**Sierrita Mountain Water Co-Op**  
10390 S. Sierrita Mountain Road 26  
Tucson, AZ 85736

## **ADDENDUM #1**

### **Sierrita Mountain Water Co-Op Water Infrastructure Improvements Project**

**Addendum #1 Date: 05/26/2026**

- *Drawings of current layout*

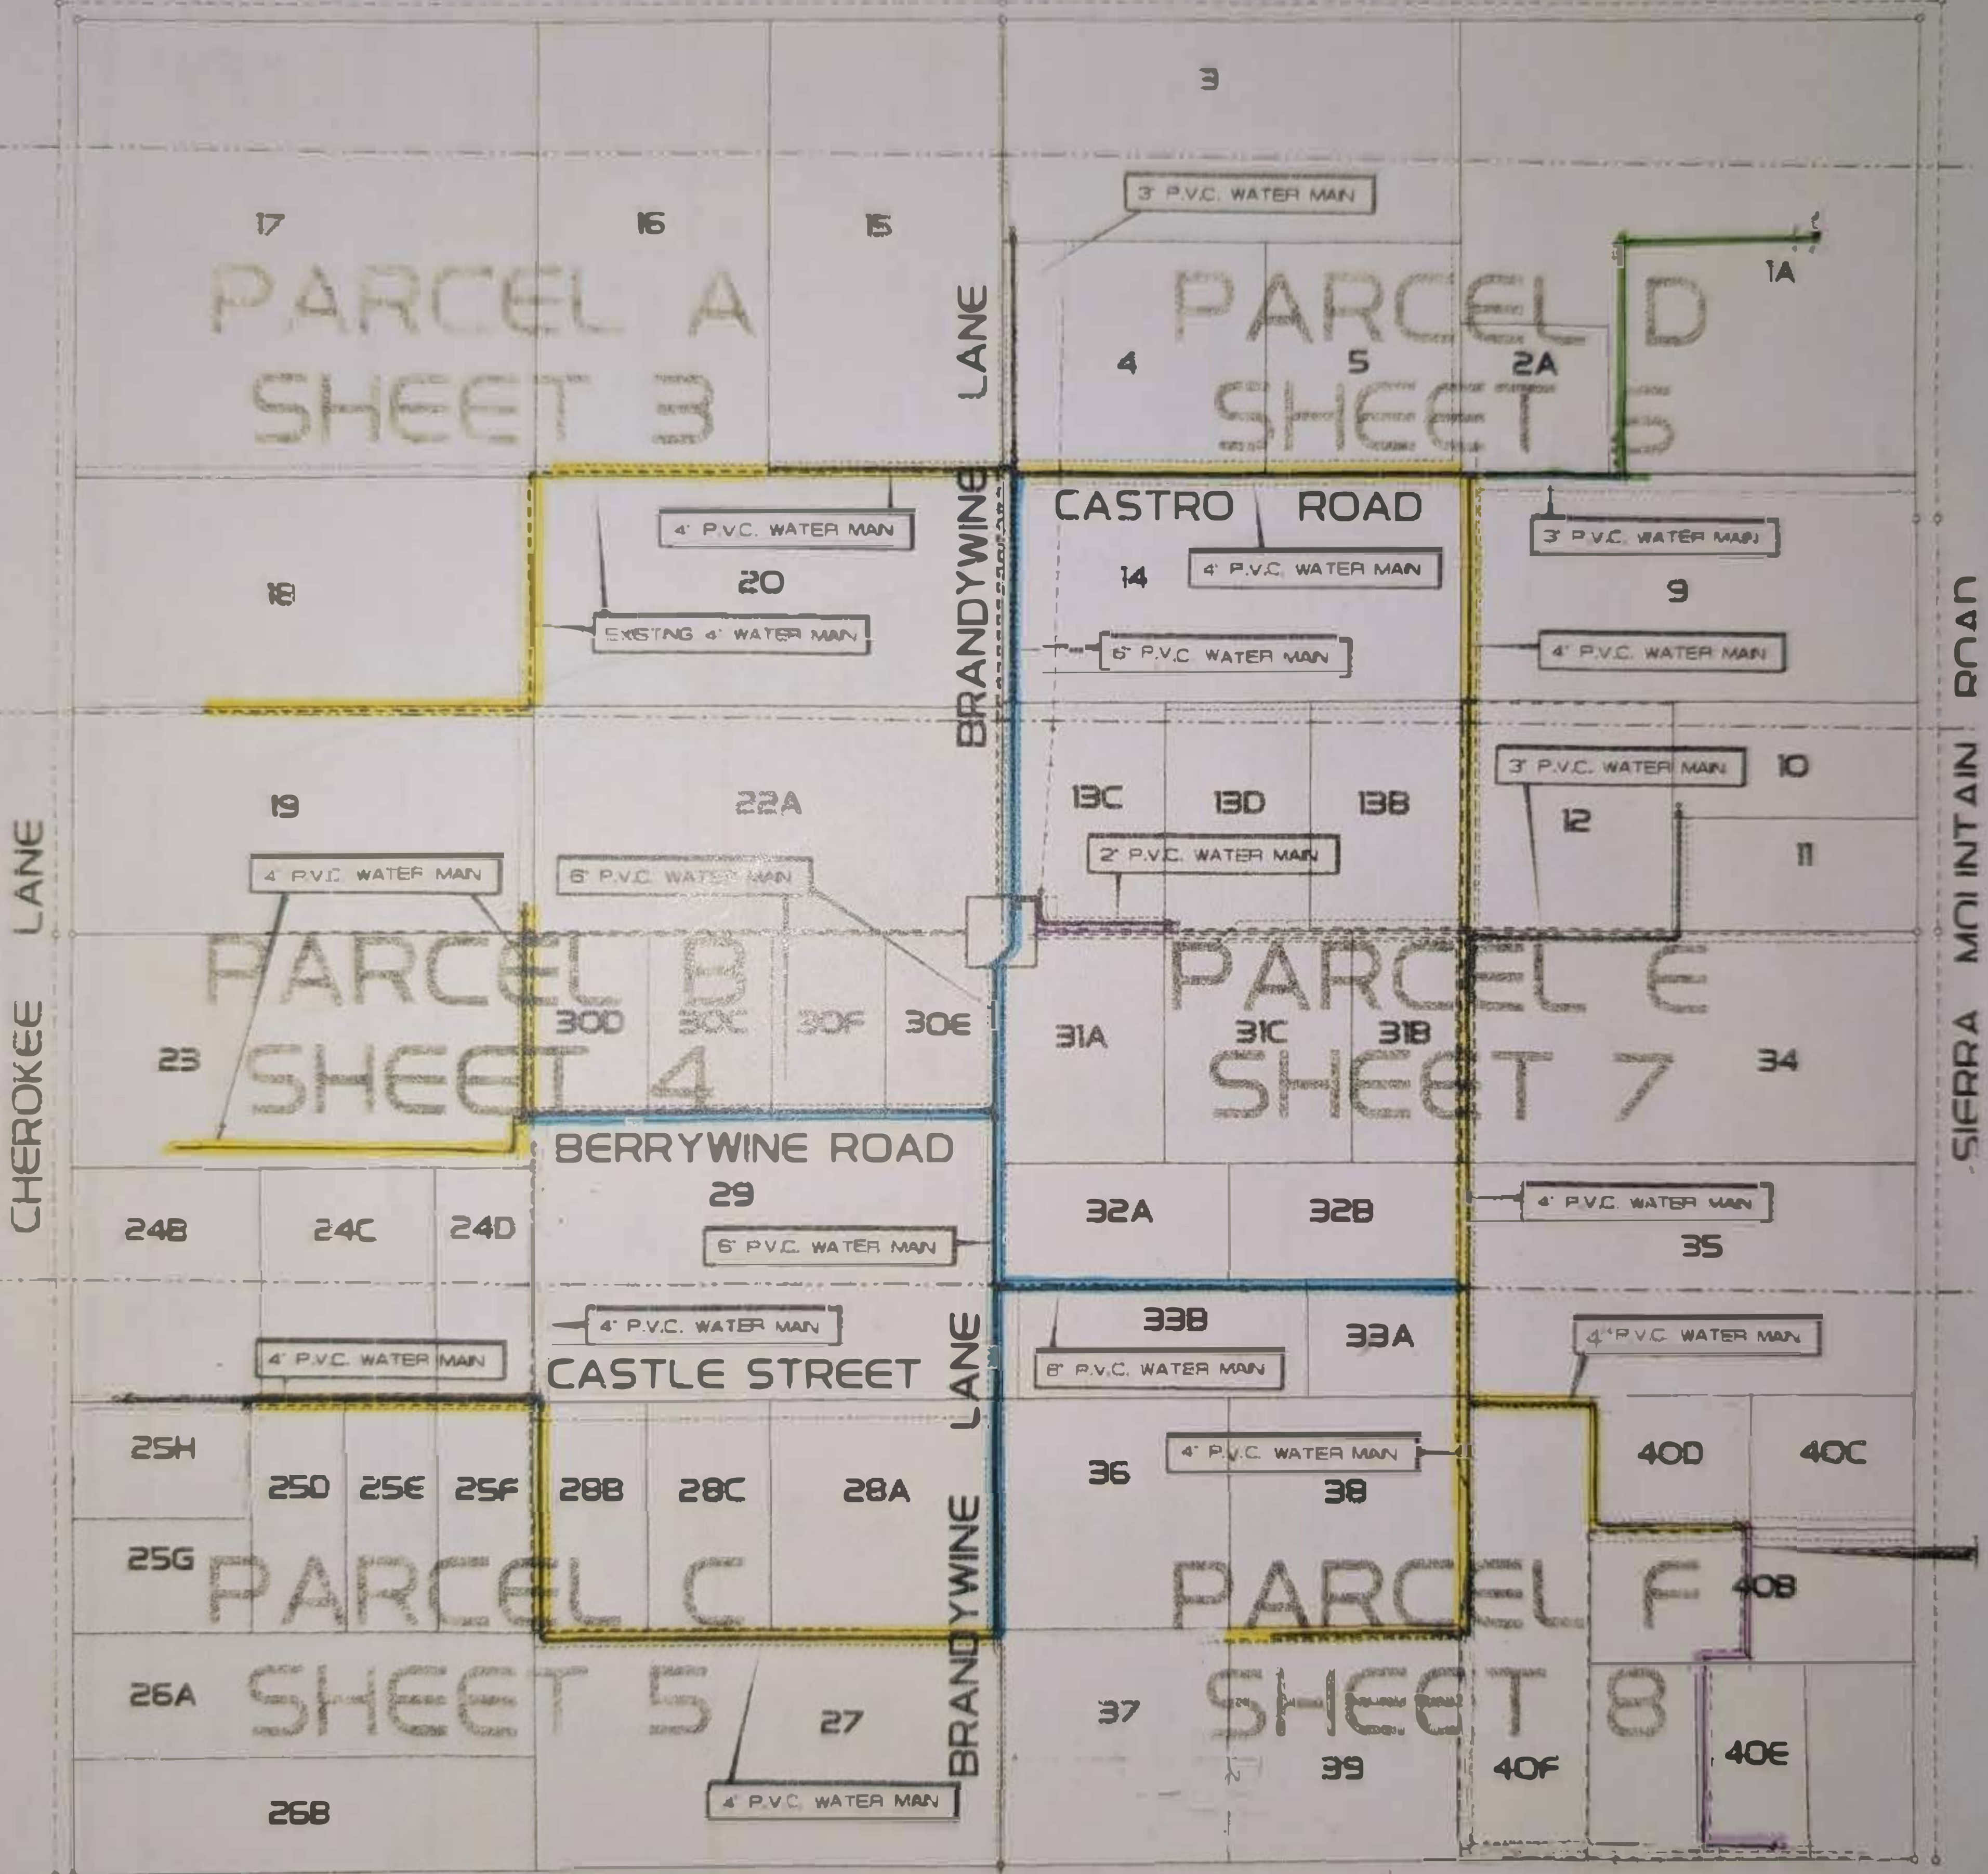
2. Question: Are there plans and specifications for this project?

Answer: There are no plans or specifications for this project. However, there are drawings that show the current layout of the system. Those are attached at the end of this addendum.
